REMARKS

AMENDMENT UNDER 37 C.F.R. § 1.111
U.S. APPLN. NO.: 09/993,686

ATTORNEY DOCKET NO. Q66753

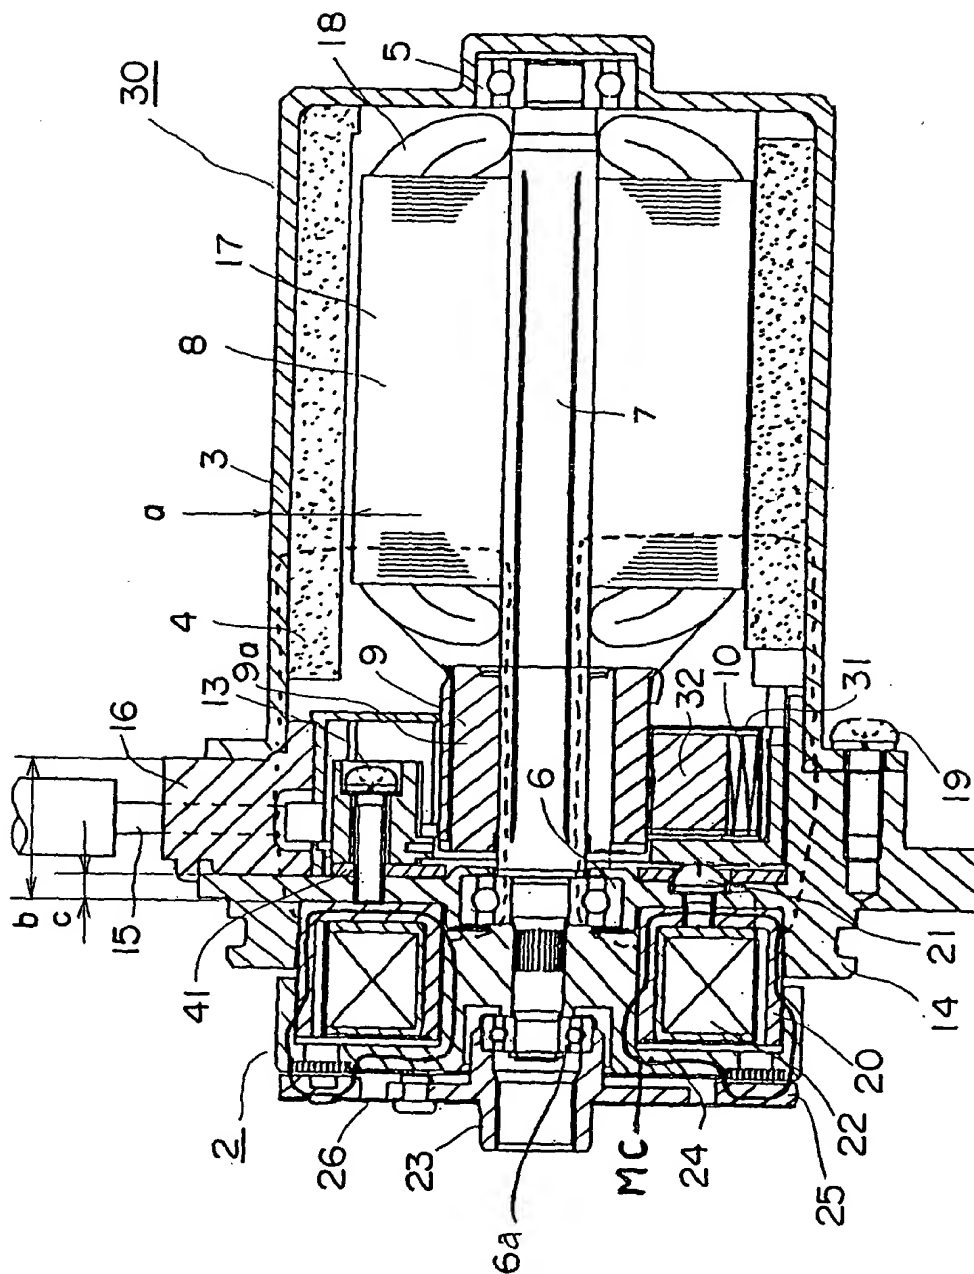
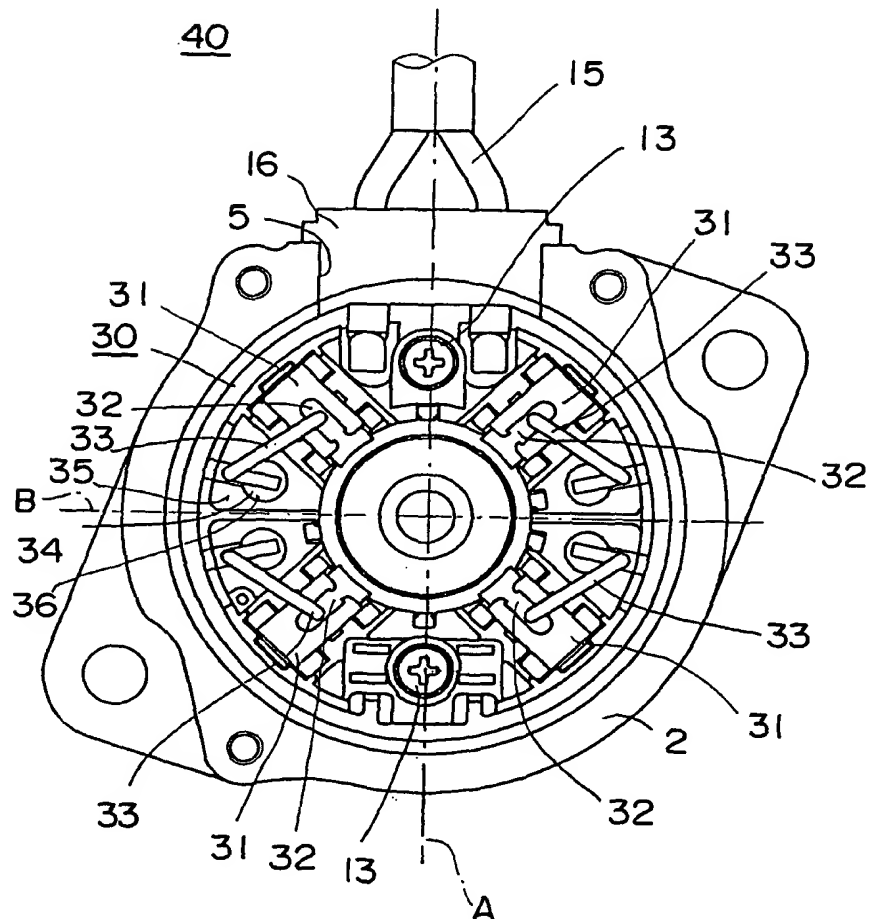
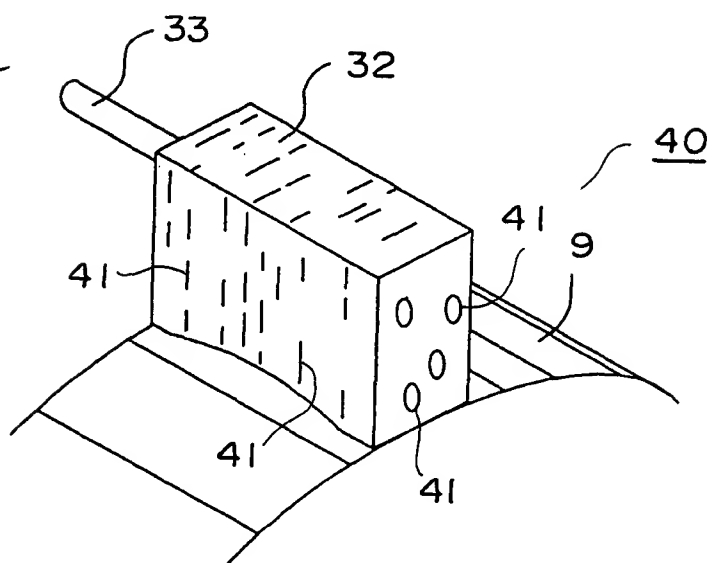
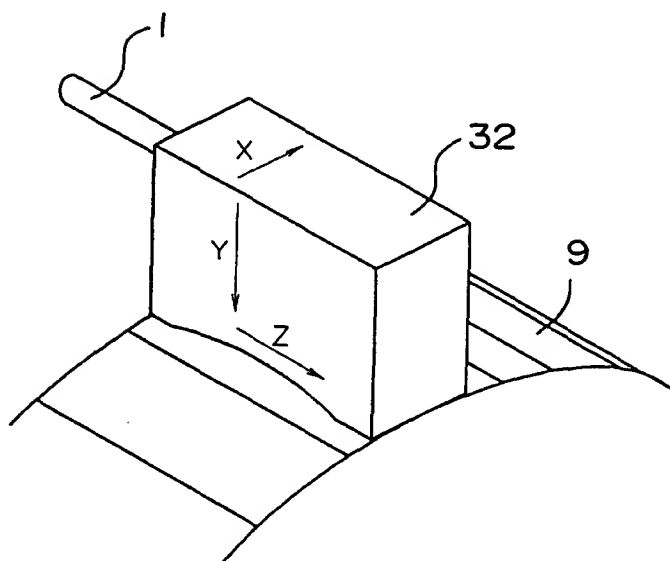
As a preliminary matter, figures 6-10 are objected to, for the reasons set forth on page 2 of the Office Action. Applicant submits herewith a Submission of Drawings (figures 6-10), and respectfully requests that the Examiner approve the enclosed figures.
